Model : GP605
GP555

Ref. No. : FF-T01-K1-000026-01

Location : ADF PICKUP ASSEMBLY

Subject : ENGINEERING DRAWING CHANGE FOR ADF PICK-UP JAM THAT OCCURS WITH THICK 200G/M2 PAPER

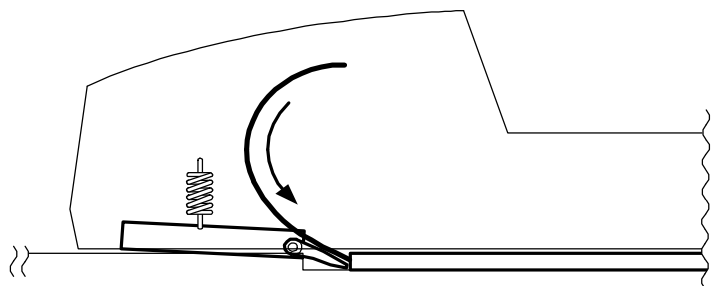
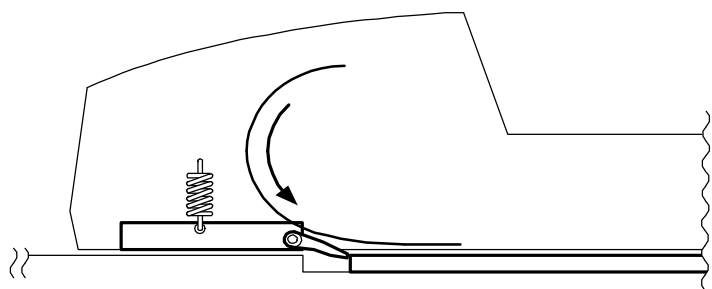
When a thick and stiff original is fed, it can push down the lower guide (for guiding the paper to the path the paper is to follow) to a position below the edge of the copyboard glass. When that occurs the original may strike the glass with the consequence of folding at the leading edge of the original or an occurrence of a pick-up jam for the original. (See Figure 1.)

Permanent measure: An engineering drawing change has been made to increase the pressure of the spring in retaining the lower guide in place (prevent it from getting pushed down) against the downward force of the stiff paper.

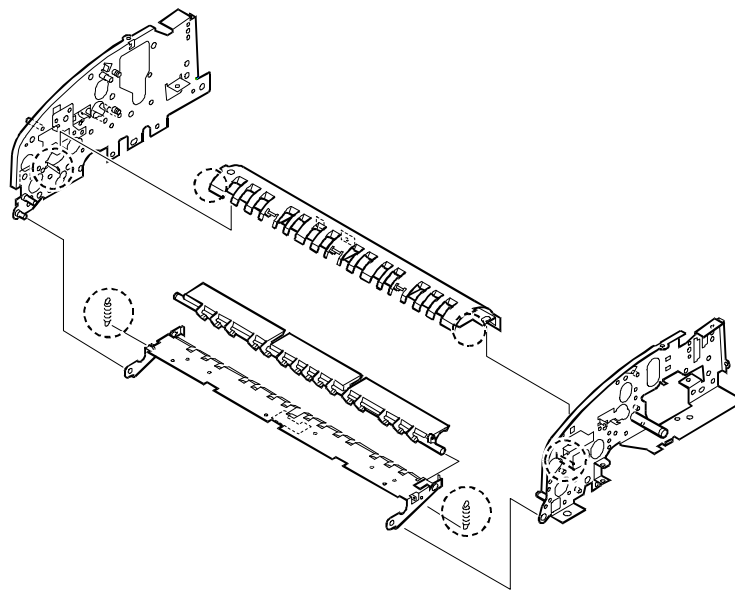
Servicing : The diameter of the spring increases due to the engineering drawing change, necessitating a change to the shape of the following parts (4 locations; Parts Catalog FY8-31DV-000, p. 32) as shown in the Figure below. It is not possible to install the new spring to the ADF without the modification and for that reason old parts and old part numbers will continue to be in use.
